Contract #: 04-0120F4Cty: SF/ALA Rte: 80 PM: 13.2/13.9File #: 69.25B**QUALITY ASSURANCE -- NON-CONFORMANCE REPORT****Location:** Changxing Island, Shanghai, P.R. China**Report No:** NCR-000406**Prime Contractor:** American Bridge/Fluor Enterprises, a JV**Date:** 27-Aug-2009**Submitting Contractor:** Zhenhua Port Machinery Company, Ltd (ZPMC), Changxing Island**NCR #:** ZPMC-0380**Type of problem:**

**Bridge No:** 34-0006**Component:** T-Stiffener Splice in OBG Segment 10CE**Reference Description:** Improper backing bar fit-up and unidentifiable material**Description of Non-Conformance:**

**Job Name:** SAS Superstructure

**Subject:** NCR No. ZPMC-0380

**Component:** T-Stiffener Splice in OBG Segment 10CE

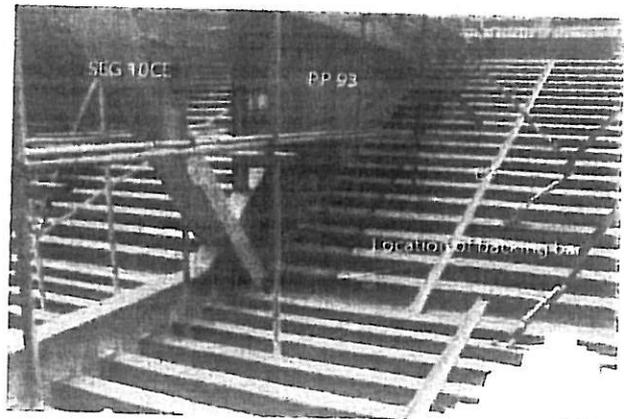
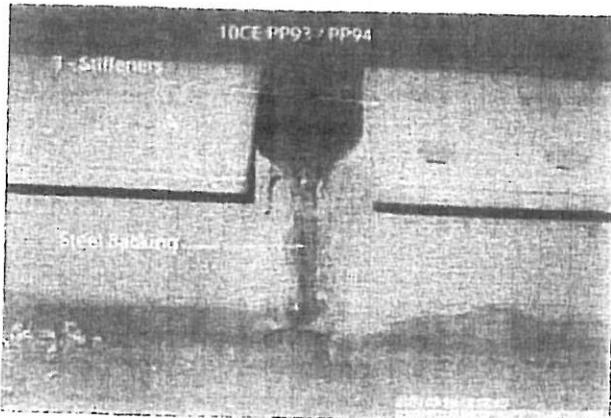
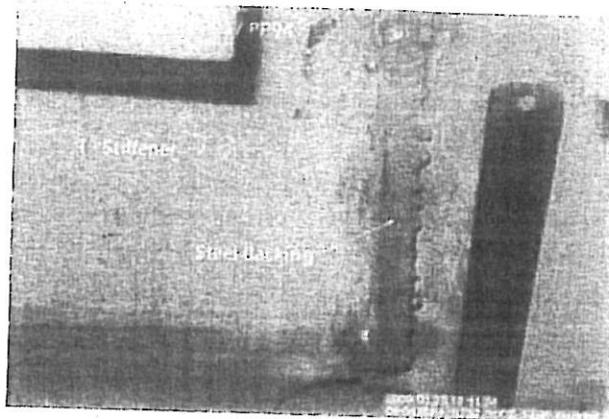
This Quality Assurance Inspector (QA) observed that the contractor has performed T-stiffeners splice weld between panel point 93 and 94 in Segment 10CE. The contractor used a steel backing on a T-Stiffener that does not conform to the code requirements. This steel backing bar is from an unknown material source and is not in intimate contact with the base metal. The location of this joint is on SP633A closest to the bottom panel.

1. AWS D1.5 Section 3.13.1 Backing: Steel backing shall conform to the following requirements: (1) When welding any approved steel described in 1.2.2, backing may be of any of the steels described in 1.2.2 except that Grade 690 (100) or 690W (100W) backing shall not be used on lower strength steels.

2. AWS D1.5 Section 3.13.5: Steel backing shall be placed and held in intimate contact with the base metal. The maximum gap between steel backing and the base metal at the weld root shall be 2 mm [1/16 in.], as shown in Figure 3.2(A).
